Page 37 and 38 of the Five Year Review Report show the PV Landfill wells that are over 140 degrees.

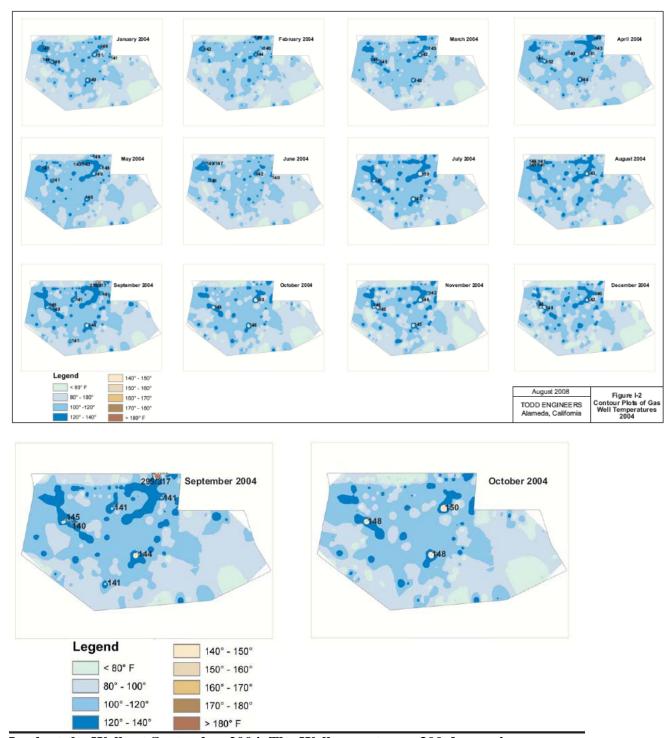
FEMA states anything over 140 degrees is a landfill fire! Many wells are over 140 degrees and should be coded in tan not blue to identify the temperatures.

Look at the Wells at September 2004. The Wells are at over 300 degrees!
